SUBJECT: NON-PROPRIETARY VERSION OF THE FINAL REPORT OF THE ULTRASONIC FLOW METER ALLEGATION TASK GROUP REGARDING THE WESTINGHOUSE/AMAG CROSSFLOW ULTRASONIC FLOW METER

**REPORT OF THE ULTRASONIC FLOW METER  
ALLEGATION TASK GROUP REGARDING THE  
WESTINGHOUSE/AMAG  
CROSSFLOW ULTRASONIC FLOW METER**

**June 7, 2004**

Figure 3. Illustration of Velocity Profile 60 Pipe Diameters Downstream of Elbow

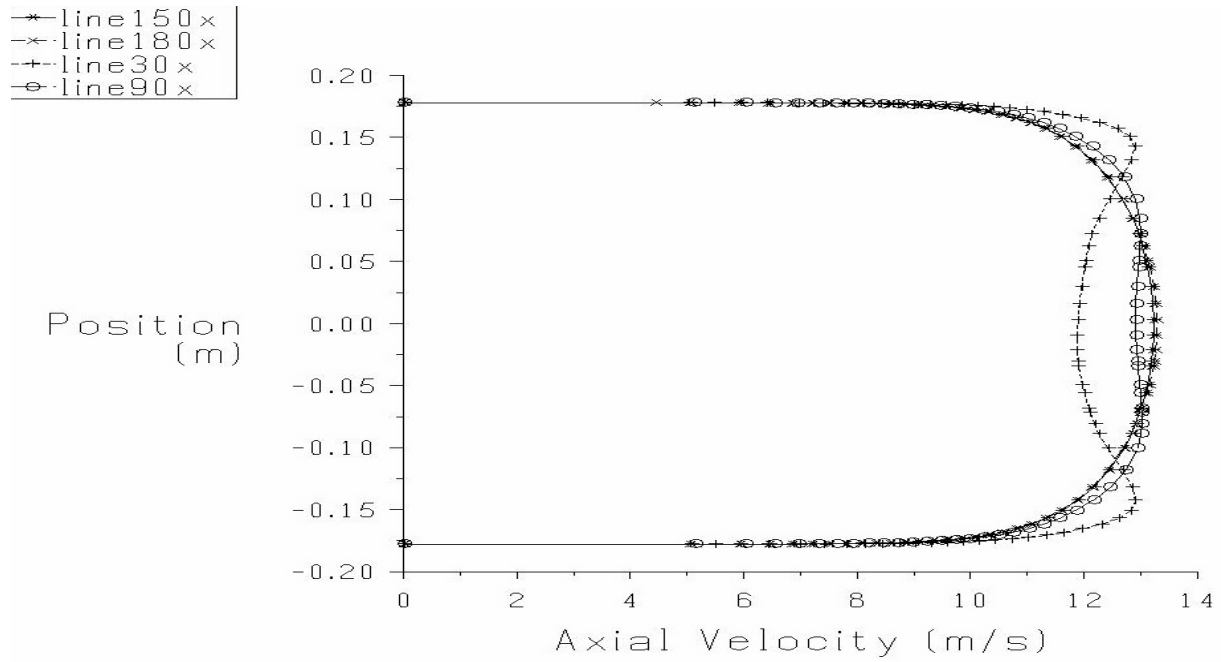
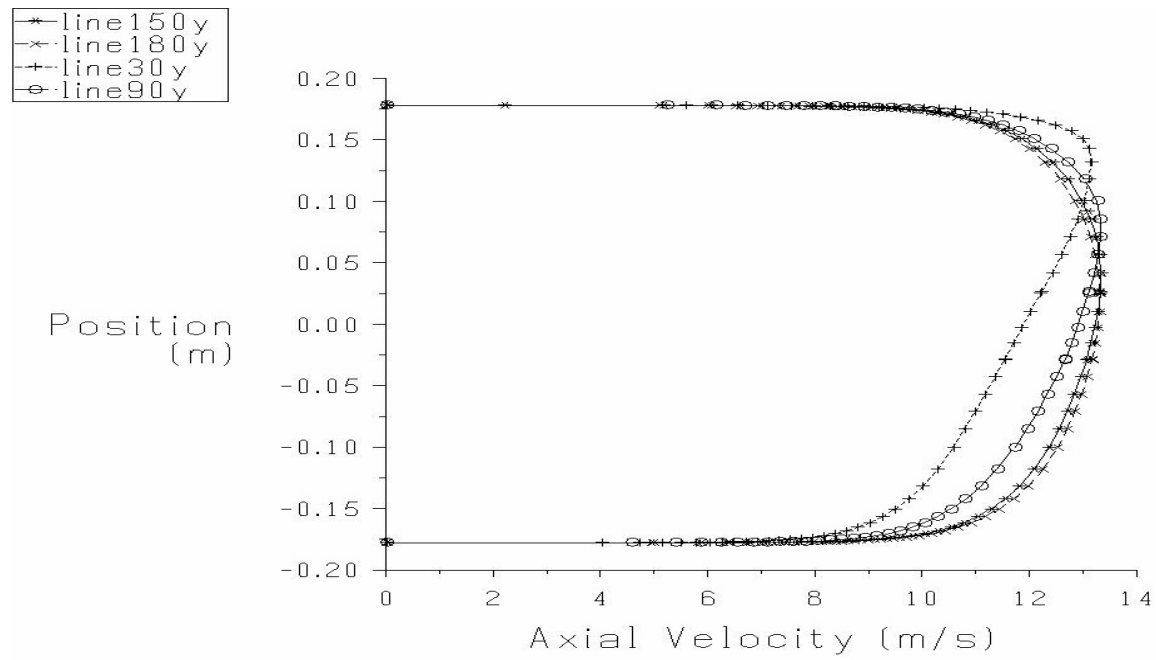
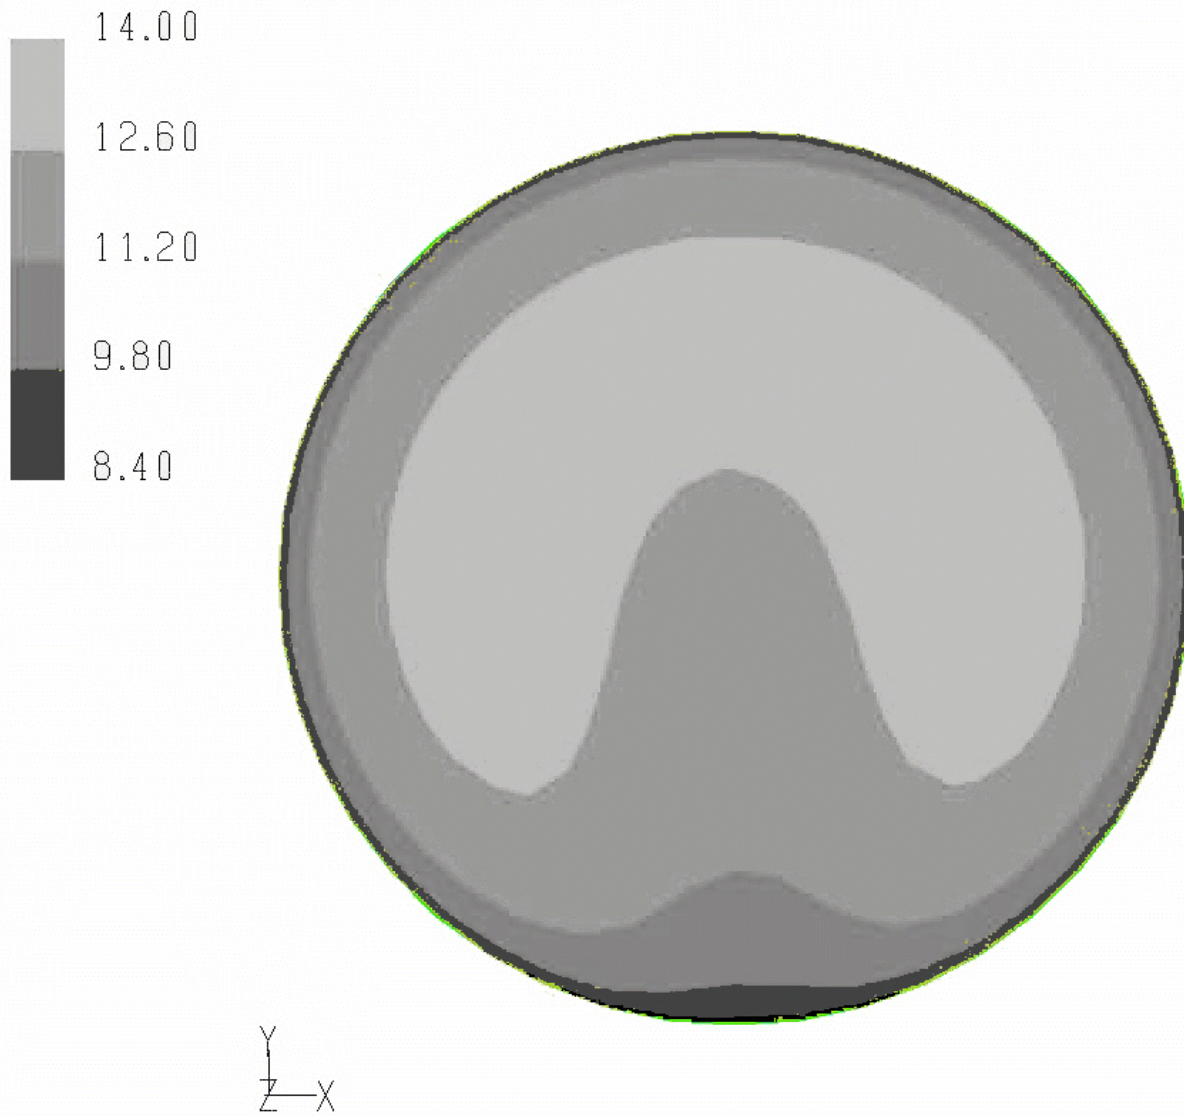
The Task Group performed preliminary analyses using Computational Fluid Dynamics (CFD) to provide insight into the effect of upstream perturbances on the velocity profile. Figure 1, from the analyses described in Appendix C, illustrates the results for the case of an upstream elbow that turns from vertical to horizontal in a 14 inch diameter pipe for conditions typical of a feedwater pipe. The view is from above. Note that the profile is still changing at 90 diameters downstream of the elbow. Figure 2 shows similar information for a view from the side that illustrates the skewed flow profile. Profile behavior perpendicular to the flow direction 60 pipe diameters downstream of the elbow is illustrated in Figure 3. Note that a UFM will typically measure different velocities for the same flow rate if rotated around the pipe. If two offset elbows had been assumed instead of one, the profile distortion would be greater.

UFMs are often installed at less than 20 diameters downstream from flow perturbations such as elbows. Clearly, UFMs are often installed where the flow profiles are not fully developed and the translation between the measured velocities and the flow rate requires correction for the profile. This correction is obtained via calibration testing in a laboratory using a representation of the plant configuration.
